**TB No. AA-15029**

**SUBJECT:** 212/412/412EP BHVM Upgrade

**DESCRIPTION:** This Technical Bulletin is being issued to allow the owner to upgrade their BHVM kit to:  
Part 1: the current software configuration setup version:  
V4.1 SP4A - V44 – (for non FastFin 212, 412, 412EP)  
V4.1 SP4A - V45 - (for 212, 412, 412EP w/FastFin installed)  
Part 2: remove the disconnect on the Tail Rotor Bracket Assembly to eliminate corrosion.  
Part 3: relocate the upper mast accelerometer for more accurate data collection (FOR 412, 412EP ONLY).

**FIGURE 1. LABEL, P/N 1209-3196-PF**

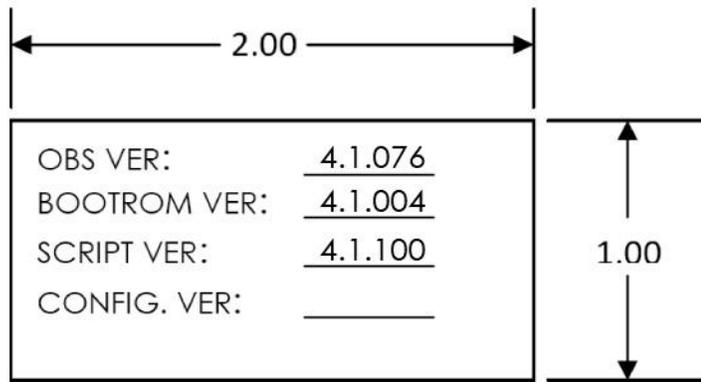
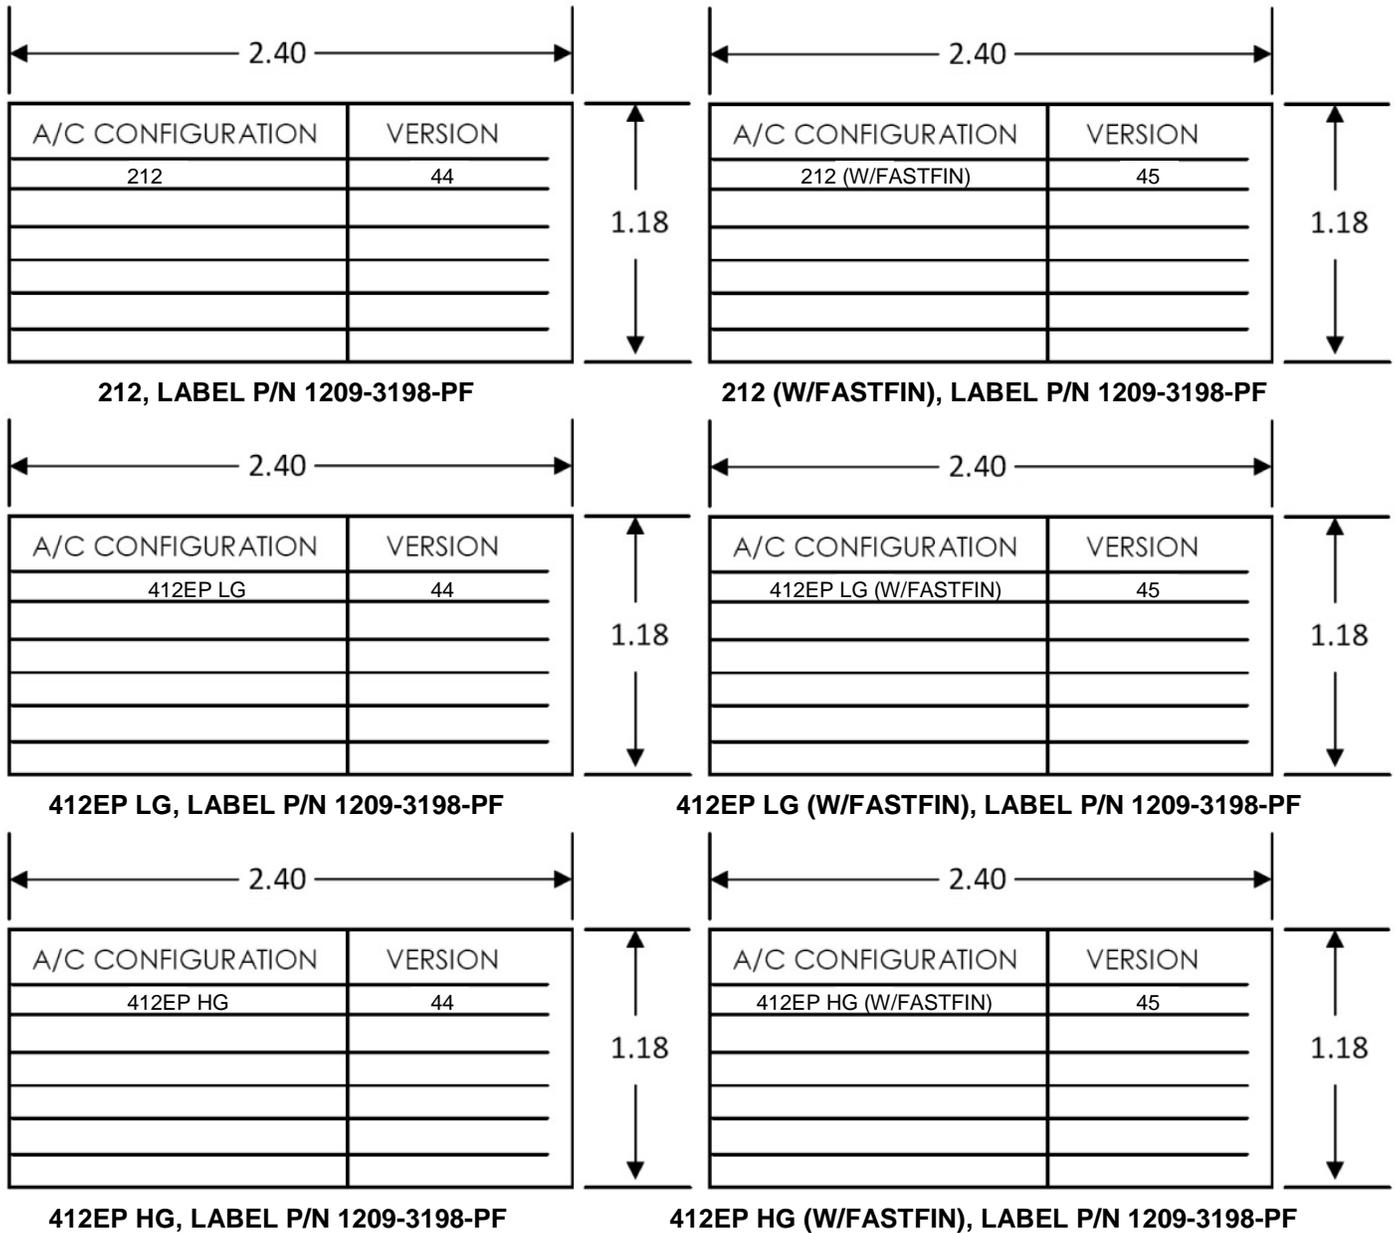
18. Ensure information on Label (1209-3196-PF) and Label (1209-3198-PF), on the MSPU unit, matches with the examples shown in Figure 1.
19. Update labels by filling in the required data or by installing new labels, if required, to correspond with your specific aircraft application, as shown in Figure 1.
20. Upgrade of PC-GBS 4.1SP4A Configuration File (CSIF) complete.

**FIGURE 2 – LOOKING INBOARD FROM R/H SIDE AT T/R 90 DEG GEARBOX  
(BALLOON NUMBERS CORRESPOND WITH APPROPRIATE INSTRUCTION STEP)**

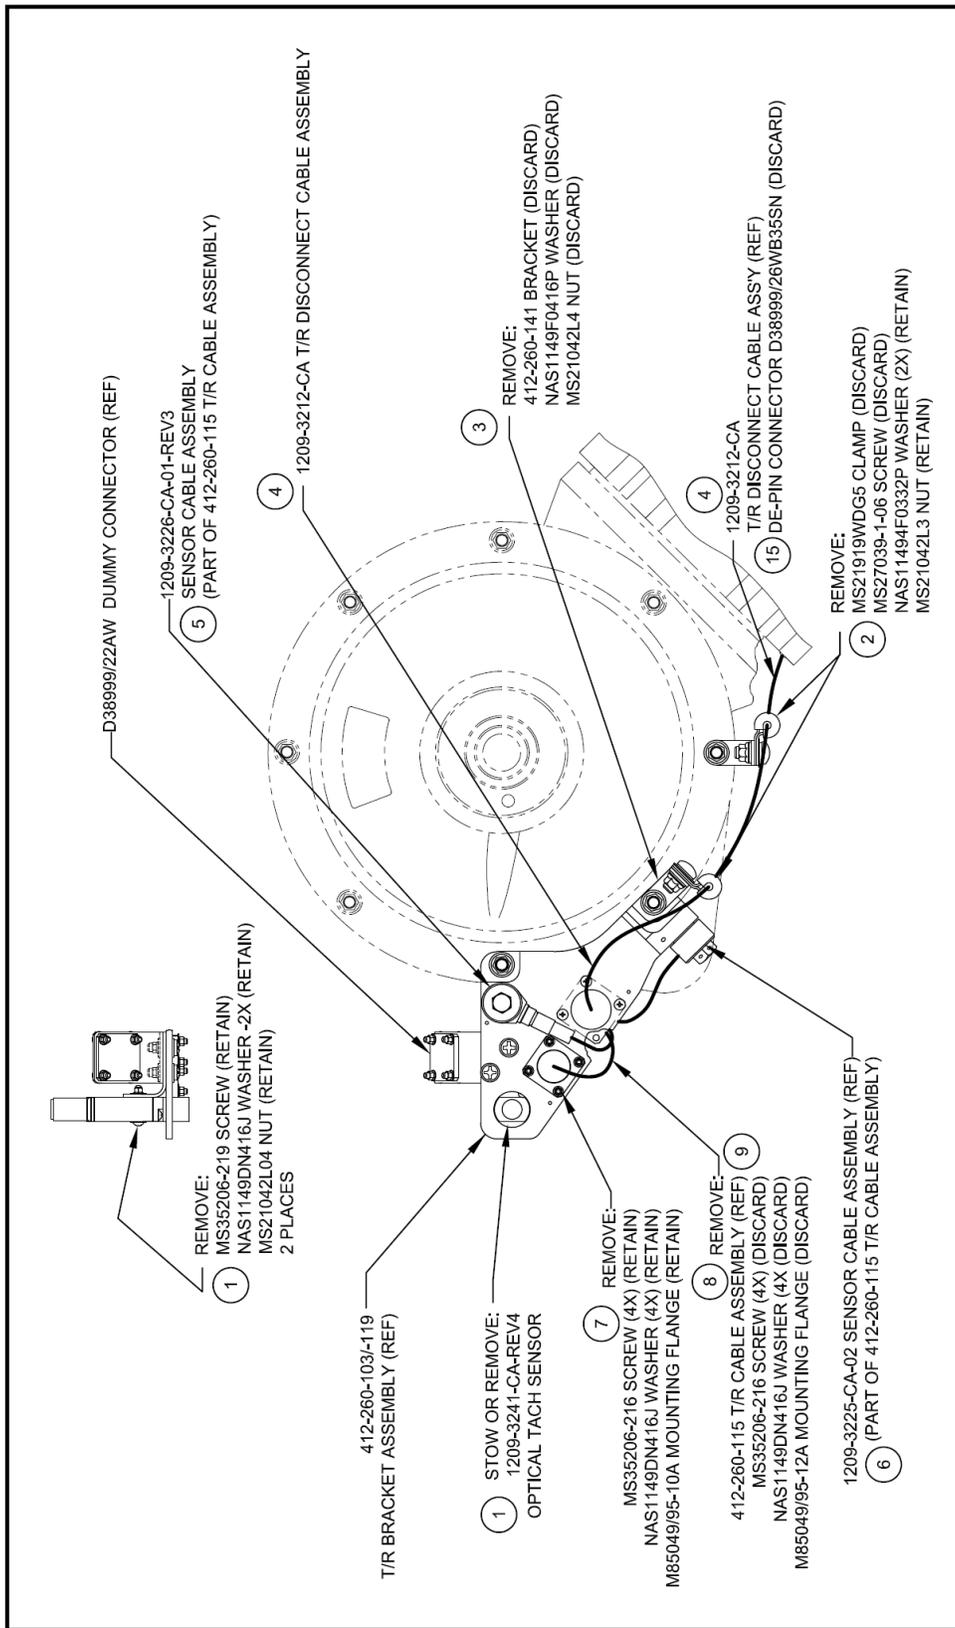
2. Remove Clamps (MS21919WDG5), Screws (MS27039-1-06), Washers (NAS1149F0332P), and Nuts (MS21042L3) that clamp T/R Disconnect Cable Assembly to 90° T/R gearbox housing, 2 places, as shown in Figure 2. Retain Washers and Nuts.

3. Remove Nut (MS21042L4), Washer (NAS1149F0416P) and Bracket (412-260-141) from T/R Bracket Assembly (412-260-103 / 412-260-119), as shown in Figure 2. Discard parts.

4. At T/R Bracket Assembly (412-260-103 / 412-260-119), mounted to tail rotor 90° gearbox, disconnect T/R Disconnect Cable Assembly (1209-3212-CA) from Connector (D38999/20WB35PN – part of 412-260-115 Tail Rotor Cable Assembly). Temporarily cap and stow loose end of T/R Disconnect Cable Assembly. Ref Figure 2.

5. On T/R Bracket Assembly (412-260-103 / 412-260-119), remove lockwire securing axial accelerometer end of Sensor Cable Assembly (1209-3226-CA-01-REV3) to Bracket Assembly. Remove accelerometer from bracket assembly by removing accelerometer bolt – ref Figure 2. Retain hardware.

6. Remove lockwire securing radial accelerometer end of Sensor Cable Assembly (1209-3225-CA-01-REV3) to Bracket Assembly (412-260-103 / 412-260-119). Remove accelerometer from bracket assembly by removing accelerometer bolt – ref Figure 2. Retain hardware.

7. Remove MS35206-216 Screws (4X), NAS1149DN416J Washers (4X) and M85049/95-10A Mounting Flange and remove receptacle end of 1209-3217-CA T/R Tach Disconnect Cable Assembly (part of 412-260-115 Tail Rotor Cable Assembly) – ref Figure 2. Retain hardware.

8. Remove MS35206-216 Screws (4X), NAS1149DN416J Washers (4X) and M85049/95-12A Mounting Flange to remove Connector (D38999/20WB35PN from receptacle end of Tail Rotor Cable Assembly (412-260-115). Remove Tail Rotor Cable Assembly (412-260-115) – ref Figure 2. Discard hardware.

9. Carefully remove the Label (CM-SCE-1/2-4H-9) and Tubing (M23053/5-108-0) from the exterior of the Tail Rotor Cable Assembly (412-260-115), ensuring no damage to wires inside, ref Figure 2.

10. De-pin T/R Tach Disconnect Cable Assembly (1209-3217-CA), Sensor Cable Assembly (1209-3225-CA-01-REV5) and Sensor Cable Assembly (1209-3226-CA-01-REV4) from Connector D38999/20WB35PN (part of 412-260-115 T/R Cable Assembly). Discard T/R Tach Disconnect Cable Assembly (1209-3217-CA) and retain Sensor Cable Assemblies (1209-3225-CA-01-REV5 and 1209-3226-CA-01-REV4) – ref Figure 2.

15. On previously stowed end of T/R Disconnect Cable Assembly (1209-3212-CA), de-pin all wires from connector (D38999/26WB35SN). Cut sockets from end of wires, minimizing the amount of wire length removed. Discard connector parts – ref Figure 2.

**FIGURE 3 – LOOKING INBOARD FROM R/H SIDE AT T/R 90 DEG GEARBOX  
(BALLOON NUMBERS CORRESPOND WITH APPROPRIATE INSTRUCTION STEP)**

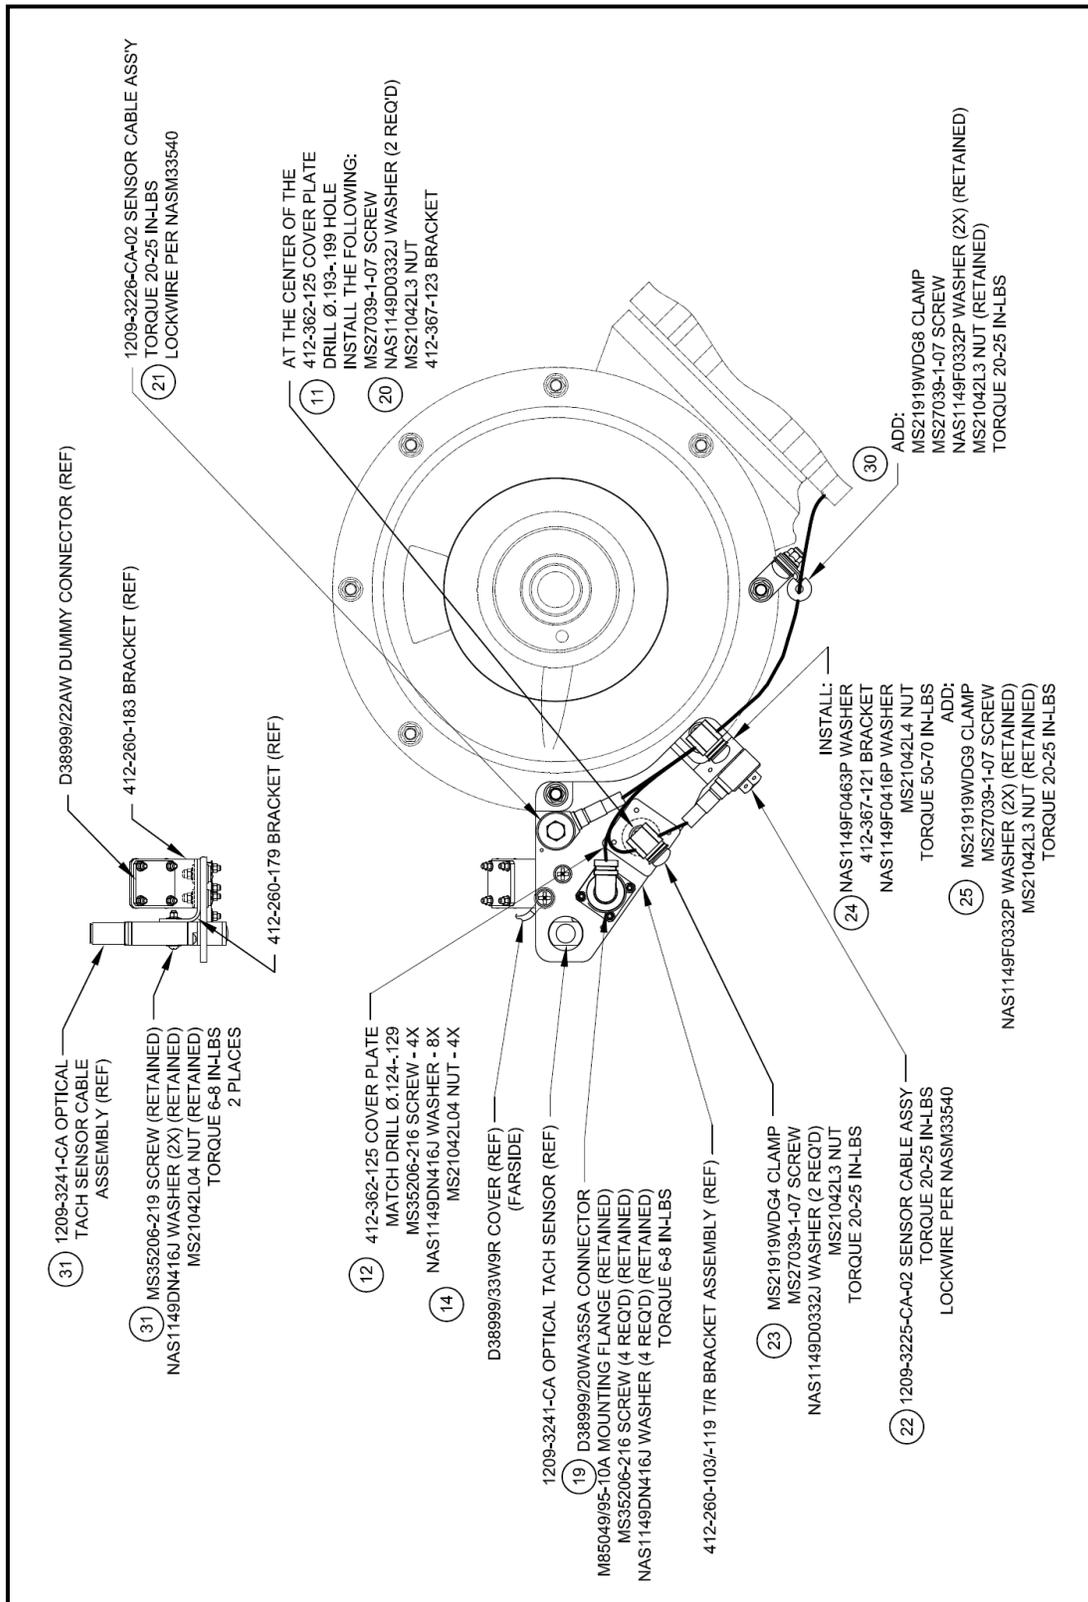
11. At the center of the Cover Plate (412-362-125), drill Ø.193-199 hole – ref Figure 3.
12. Match Drill Ø.124-.129 Cover Plate (412-362-125) to T/R Bracket Assembly (412-260-103 / 412-260-119), as shown in Figure 3.

13. Brush alodine bare aluminum per MIL-DTL-5541.
14. Install Cover Plate (412-362-125) to T/R Bracket Assembly (412-260-103 / 412-260-119) using Screws (MS35206-216), Washers (NAS1149DN416J) – under screw heads and nuts, and Nuts (MS21042L04), as shown in Figure 3.

20. Orient Bracket (412-367-123) and install to Cover Plate (412-362-125) using Screw (MS27039-1-07), Washer (NAS1149D0332J) and Nut (MS21042L3), as shown in Figure 3. Torque to 20-25 in-lbs.

21. Orient and attach Sensor Cable Assembly (1209-3226-CA-01-REV4) to T/R Bracket Assembly (412-260-103 / 412-260-119) with retained hardware, as shown in Figure 3. Do not torque fastener at this time.

22. Orient and attach Sensor Cable Assembly (1209-3225-CA-01-REV5) to T/R Bracket Assembly (412-260-103 / 412-260-119) with retained hardware, as shown in Figure 3. Do not torque fastener at this time.

23. Route Sensor Cable Assembly (1209-3225-CA-01-REV5) through Clamp (MS21919WDG4) and install clamp to Bracket (412-267-123), as shown in Figure 3, using Screw (MS27039-1-07), Washers (NAS1149D0332J) – 2X and Nut (MS21042L3). Torque to 20-25 in-lbs.

24. At the lower attaching point for the T/R Bracket Assembly (412-260-103 / 412-260-119) to the tail rotor 90° gearbox, install Washer (NAS1149F0463P), Bracket (412-367-121), Washer (NAS1149F0416) and Nut (MS21042L4), as shown in Figure 3.

25. Route cable from T/R Optical Tach Sensor Disconnect, Sensor Cable Assembly (1209-3225-CA-01-REV5) and Sensor Cable Assembly (1209-3226-CA-01-REV4) through Clamp (MS21919WDG9) and loosely install clamp to Bracket (412-367-121) using Screw (MS27039-1-07), Washers (NAS1149F0332P) – 2X and Nut (MS21042L3) – ref Figure 3. NOTE: Rotate clamp as required to clear Nut (MS21042L4). Do not Torque at this time.

27. With cables routed as shown in Figure 3, splice Sensor Cable Assembly (1209-3225-CA-01-REV5) and Sensor Cable Assembly (1209-3226-CA-01-REV4) to T/R Disconnect Cable Assembly (1209-3212-CA) using D-150-0174 Shielded Cable Splice Kit. Refer to RCPS-150-02 Installation Procedure for TE Connectivity Shielded Cable Splice Kits with Mini-Seal Crimp Primary Splices for installation instructions.

28. Re-check routing of wires and adjust clamping points, if required. Torque clamp fasteners as shown on Figure 3.
29. Torque fasteners securing the Sensor Cable Assembly (1209-3225-CA-01-REV5) and Sensor Cable Assembly (1209-3226-CA—01-REV4) accelerometers to 20-25 in-lbs. Lockwire per NASM33540. Ref Figure 3.

30. Secure wiring to tail rotor 90° gearbox at the 6 o'clock position using Clamp (MS21919WDG8), Screw (MS270329-1-07), Washers (NAS1149F0332P) – 2X, and Nut (MS21042L3) as shown in Figure 3. Torque to 20-25 in-lbs.
31. If previously removed, re-install Optical Tach Sensor, 1209-3241-CA-REV5, to T/R Bracket Assembly, 412-260-119, using Screw, MS35206-219, Washer, NAS1149DN416J, and Nut, MS21042L04, as shown in Figure 3. Torque to 6-8 in-lbs.
32. Mark/label wires per AC43.13-1.
33. Reference appropriate ICA report and perform an accelerometer check of the modified components.
34. Removal of T/R Bracket Disconnect complete.

**FIGURE 4 – SCHEMATIC WITH T/R ACCELEROMETER BRACKET DISCONNECT**

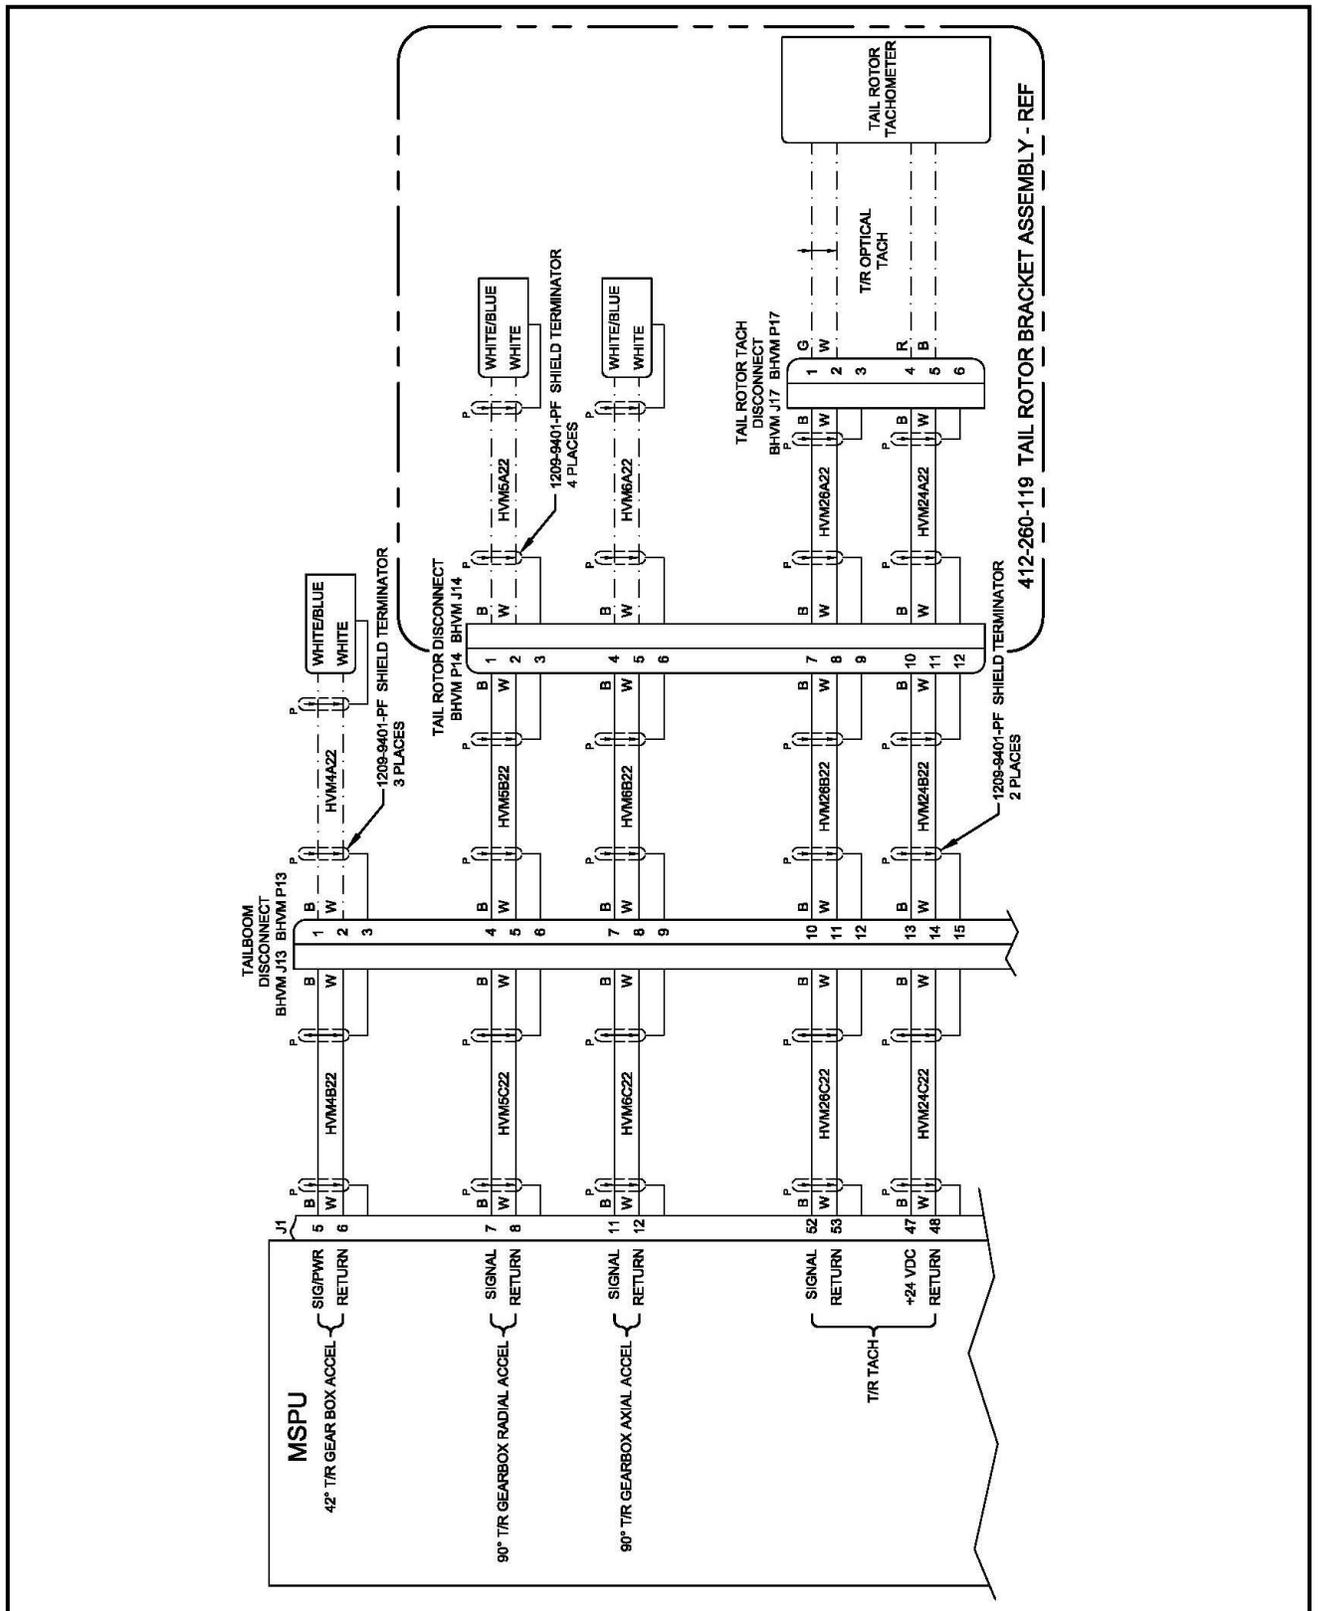
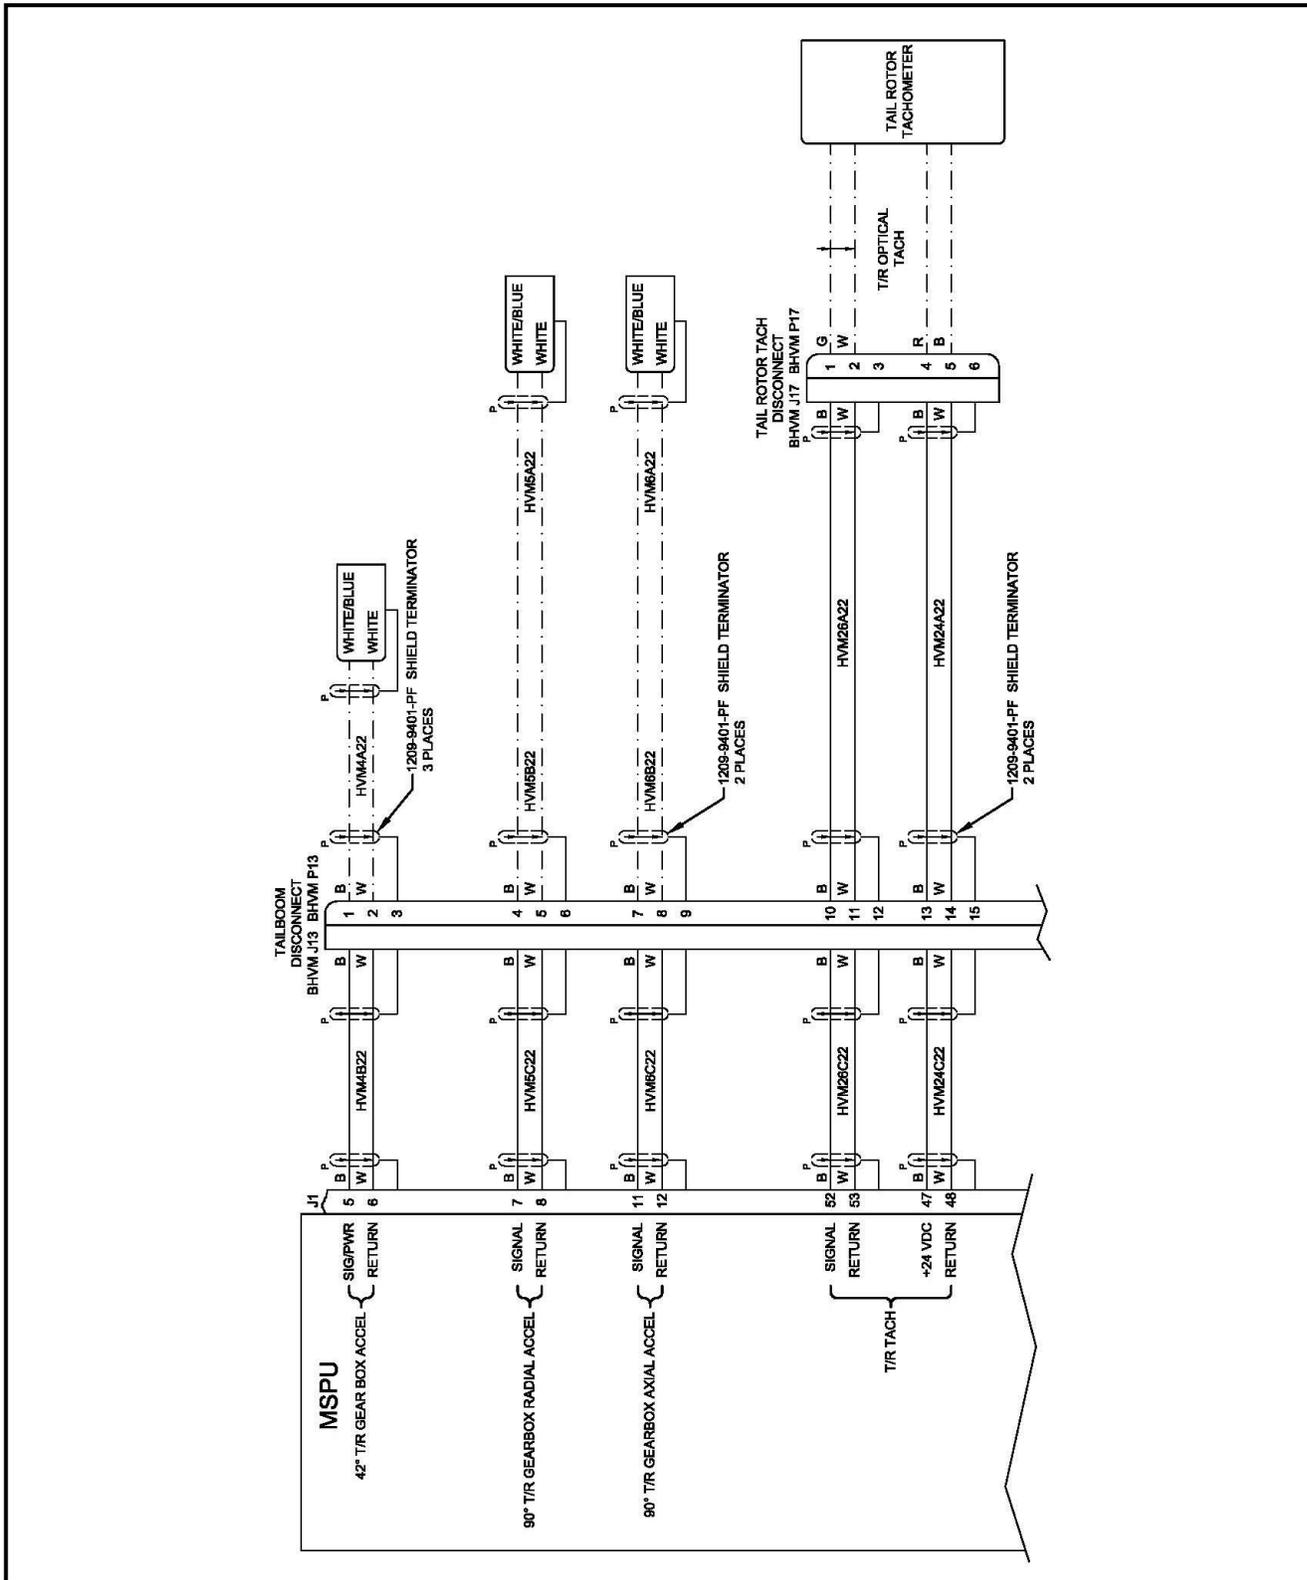
16. Locate and carefully pull wires marked HVM24A22 and HVM26A22 through Backshell Assembly (412-263-101). Feed wires from braided end of Backshell Assembly – ref Figure's 4, 5 and 6.
